Product Change Notice (PCN)

PCN Number: **PCN-0374346R-01**

Product(s) Affected: **CST-931AP**

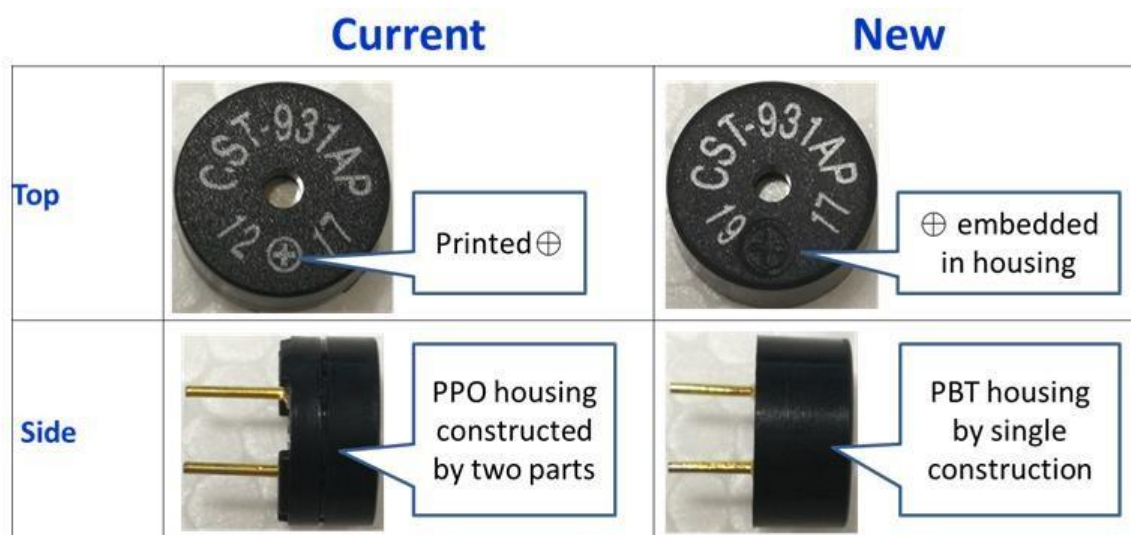
Reason(s) for Change: *To ensure product housing stays uniform and offer a higher temperature rating.*

Description of Change: *Housing changing from two pieces (top+bottom) to one single plastic piece, plastic changing to higher temperature PBR material, positive terminal marking embedded into housing instead of printed.*
